Housing Options – PSC Work Session 7/10/18 (continued from 6/26/18)

Legend: Red text = PSC straw polls from 6/26. Blue text = staff notes.

Issue C – In what building form(s)?
 See diagrams below: #1-6 for three units; #7-13 for four units

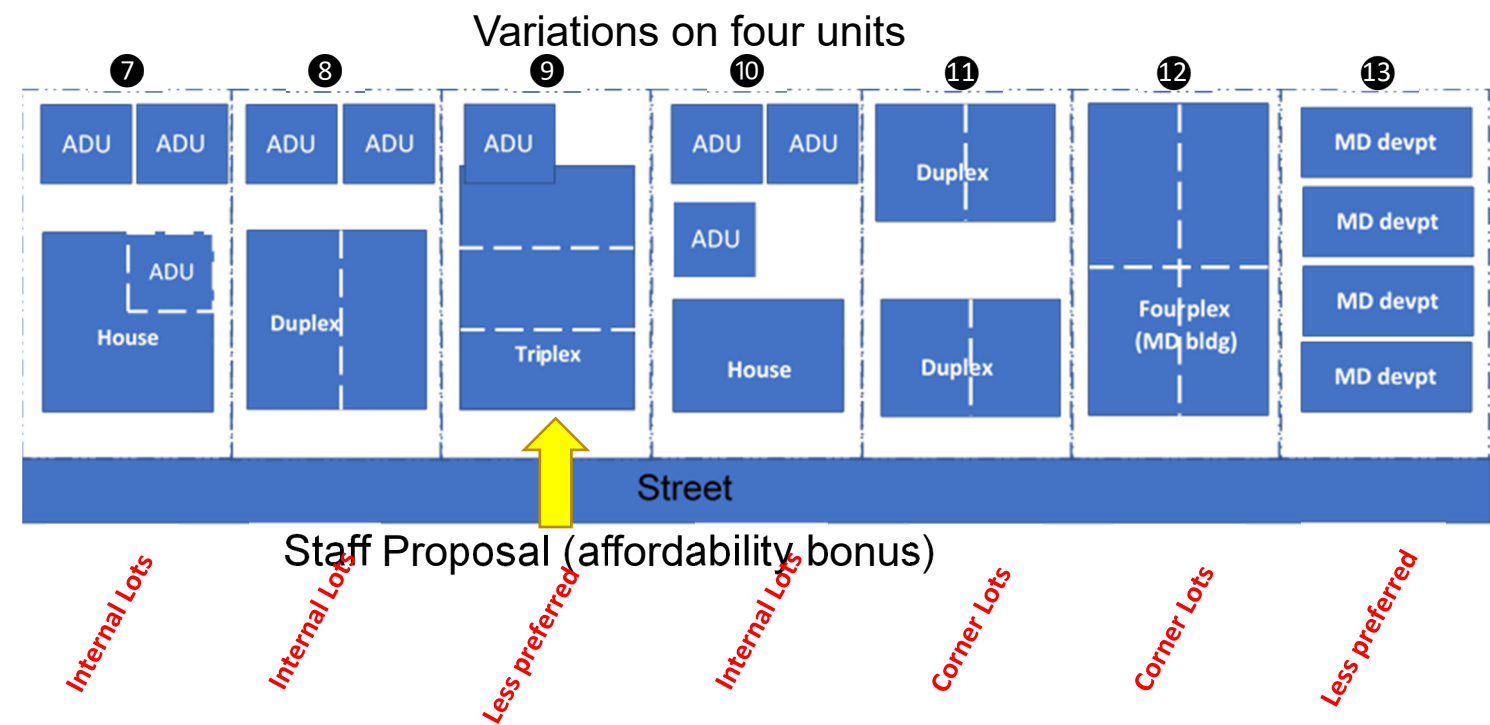
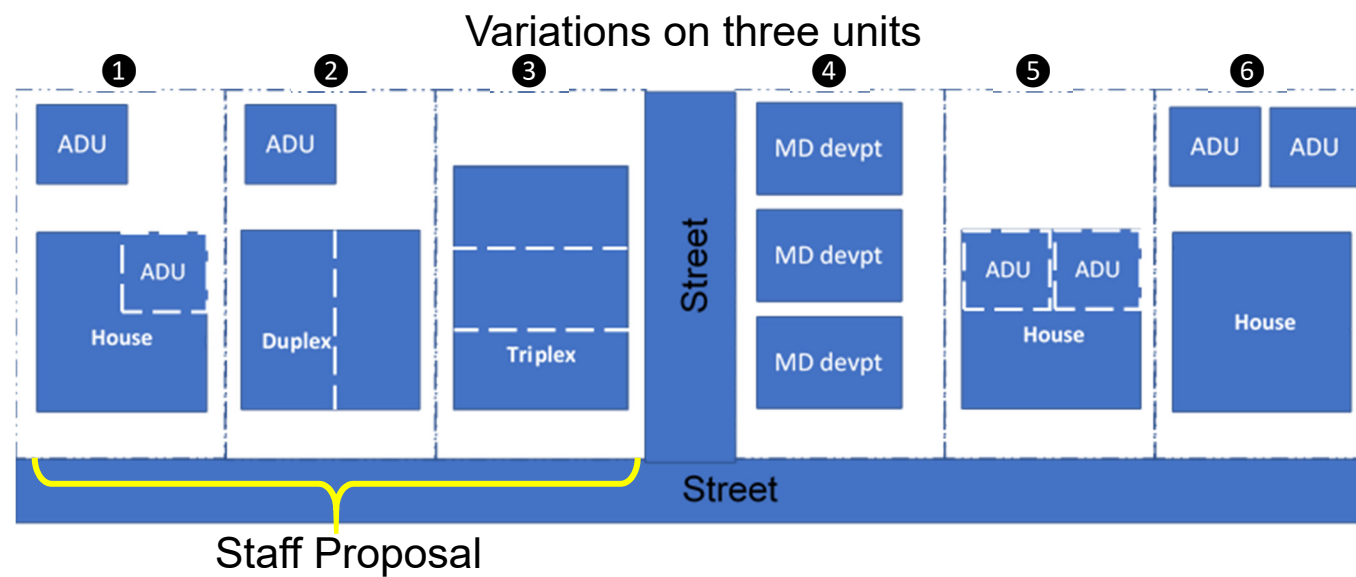
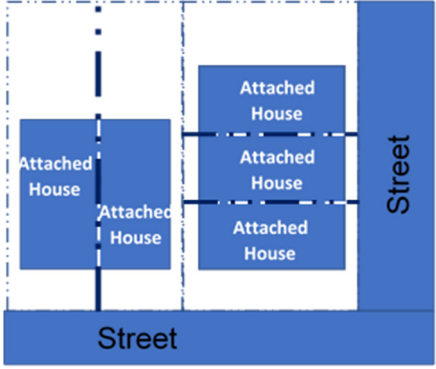
Scheme # in diagram below	Location of Lot	
	Internal Lot	Corner Lot
#7	9	7
#8	9	8
#9	5	6
#10	7	6
#11	8	9
#12	7	8
#13	5	6

#9 and #13 were least preferred overall
 #7, #8 and #10 were more preferred on internal lots
 #11 and #12 were slightly favored on corner lots

Comments RE: Form:

- Provide a number, but don't prescribe a form
- Need to see more varieties
- Focus is on the appearance from the street, ADUs seem to work better on internal lots, while corners can have the units in a building all orient to the street
- No more than 3 structures. 4 is too many structures (not units)
- From 6/7 – PSC direction: allow up to 2 ADUs internal or detached form the structure in any configuration.
- Difficult to decide without knowing the outcome of the scale discussion (will buildings get larger with more units or not)
